GOVERNMENT/INDUSTRY AERONAUTICAL CHARTING FORUM 00-02

Recommendation Document

Subject: Precision FAF (PFAF) Location for RNAV Procedures at ILS Runways

Amdt 12A 00111 294
VOR/DME RWY 1 PRESQUE ISLE/NORTHERN MAINE REGIONAL ARPT AT PRESQUE ISLE (PQI)
 AL-331 (FAA) PRESQUE ISLE, MAINE

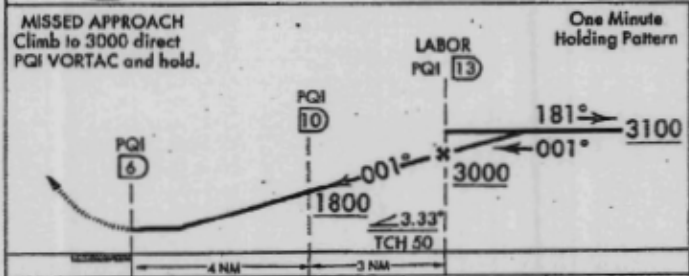
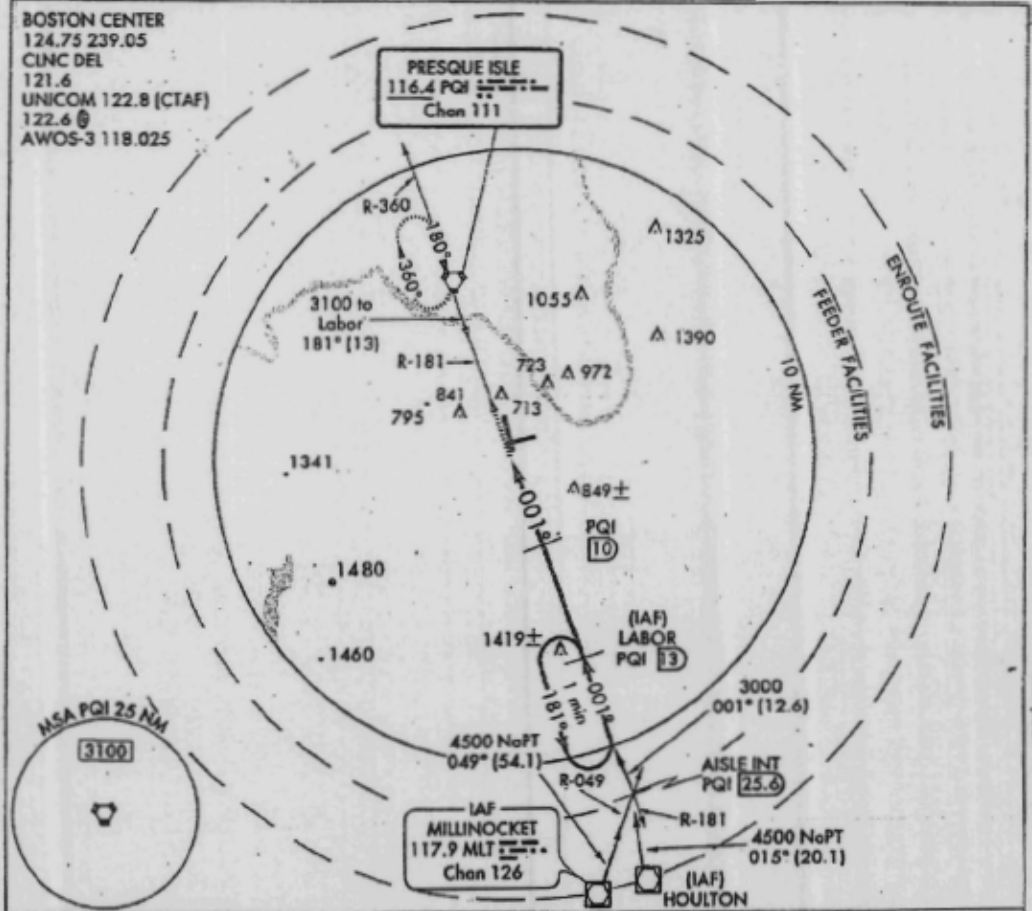
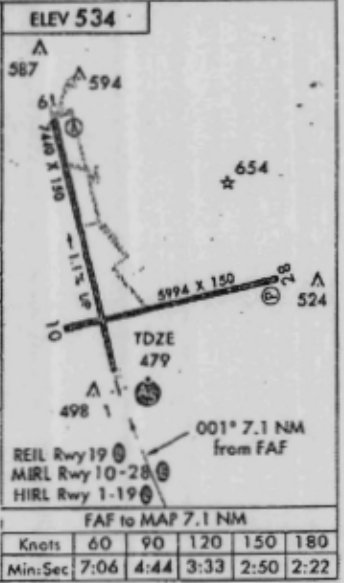
CASE 1. If the present LOC FAF is defined by DME, intersection or radar, the LOC FAF will be moved to coincide with the RNAV FAF which will be placed at the vertical descent angle interception point. An example is the ILS RWY 11 at Crescent City (CEC), CA. When a RNAV procedure is developed for this runway, the ILS procedure must also be amended to move SLAMM DME fix to the point where the 1700' MSL altitude intercepts the glidepath. In this case, SLAMM will be moved .1 - .2 NM away from runway 11 threshold. SLAMM will also be the RNAV FAF.

ILS RWY 4

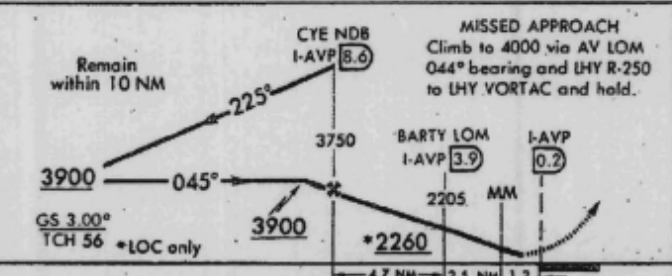
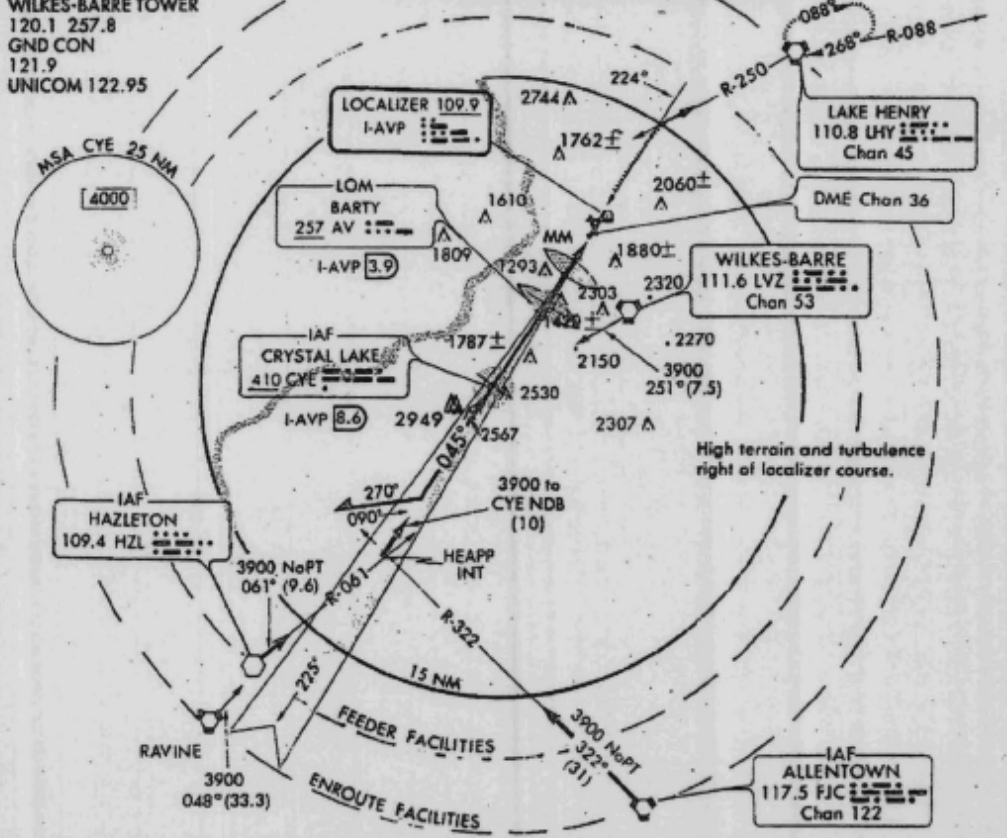
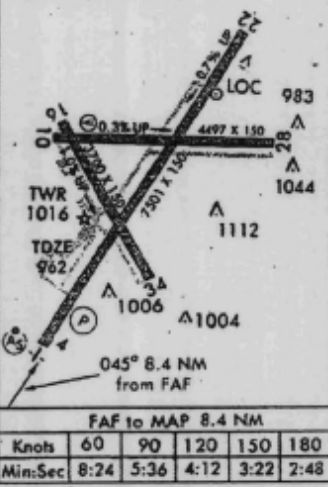
CASE 2. If the LOC FAF is defined by a facility such as a LOM, which cannot be moved, the present facility name will be assigned to the ILS PFAF. The RNAV FAF will be co-located with the ILS PFAF and share the common name. The facility will remain the LOC FAF and the facility identification will serve to mark the location for navigation database purposes. An example is the ILS RWY 25R at Livermore (LVK), CA. When a RNAV procedure is developed for this runway, the ILS procedure must also be amended to move REIGA to the point where the 2800' MSL altitude intercepts the glidepath. In this case, REIGA will be moved 1.2 NM away from runway 25R threshold.
